Access Compliance Report

Public Rights-of-Way

(Curb Ramps)

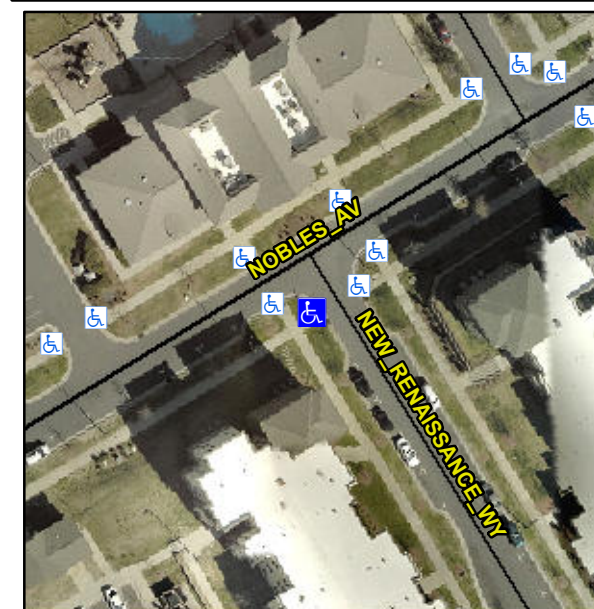
Intersection ID: 52573	Main Street: NEW RENAISSANCE_WY	Cross Street: NOBLES_AV	Location: SW
ADA ID: 32977265B197	Ramp Type: Perp	Initial Pass/Fail: Fail	Overall Compliance: No
Severity Score: 1.25			
Codes/Mitigation Info/Possible Solution		Field Measurements/Component Compliance

R304.5.3

Remove & Replace Entire Ramp.
